APPLICATION NO.	FILING DATE	FIRST NAMED INVENTOR	ATTORNEY DOCKET NO.	CONFIRMATION NO.
10/060,300	02/01/2002	Takao Murakami	06753.0495	7085

Office Action Summary

DETAILED ACTION

*Regarding
1-5, 10
Claims*

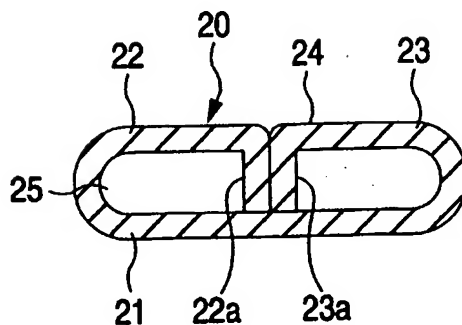
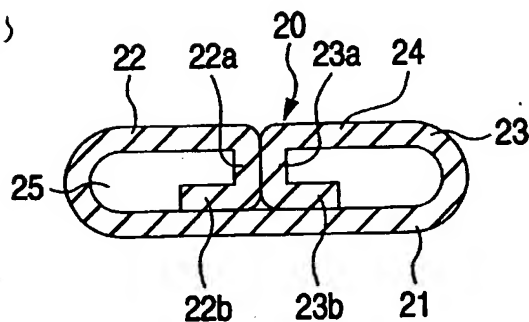
Claims 1-5, 10, 11, 13, 14, and 16 are rejected under 35 U.S.C. 102(b) as being anticipated by Fukuda et al. ("Fukuda"). Per claims 1, 10, 14, and 16, Fukuda discloses a male terminal fitting 1 comprising a plate-shaped contact protrusion 20 formed at one side of said male terminal fitting for mating with a female terminal fitting; and a conductor clamping portion located at the other side of said male terminal for

clamping a conductor of an electric wire; wherein said plate-shaped contact protrusion includes a base plate component (see attachment) longitudinally extending from said conductor clamping portion in an elongated plate shape, an overlapping fold plate component laterally extending from one side of said base plate component and folded to overlap with said base plate component, and a flatness securing plate component overlapping with said base plate component and said overlapping fold plate component to ensure flatness conditions of said base plate component and said overlapping fold plate component.

Per claim 2, said overlapping fold plate component includes a side plate element (see attachment) upwardly extending from one side of said base plate component in a plane substantially perpendicular to said base plate component, and a top plate element extending from said side plate element in a plane substantially parallel to said base plate component; and wherein said flatness securing plate component overlaps said base plate component and said top plate element.
